PRODUCT / PROCESS CHANGE NOTIFICATION

1.1 Company		STMicroelectronics International N.V
1.2 PCN No.		ADG/18/11072
1.3 Title of PCN		Die Layout change for STD18NF03L
1.4 Product Category		Power MOSFET
1.5 Issue date		2018-09-17

Die Layout change on STD18NF03L

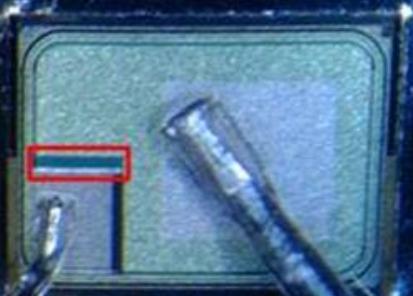
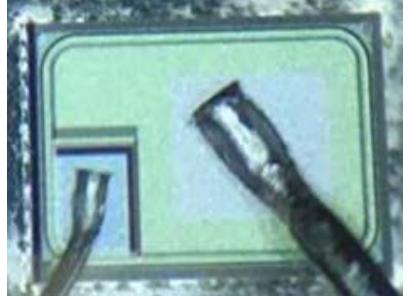
ST Part number:	ST PNs: STD18NF03L Package: DPAK
Reason and background of the change	Throughput increase thanks to an improved pattern recognition during wire bonding process
Detailed description of change(s), including affected type of changes	Gate Pad layout modification to improve the device workability (improve pad recognition) during bonding and, as a consequence, assembly yield improvement. Change Explanation In order to improve pattern recognition, we decided to introduce a clear distinction between black and white on gate pad area. This clear distinction has been implemented by putting the inverted “L”, used for pattern recognition, on top of the field oxide. By doing this we avoid Gate Metal to overlie with “L” on top side of Gate Pad. Here below a detailed explanation of the change:
Die Layout (Current)

Die Layout (Proposal)
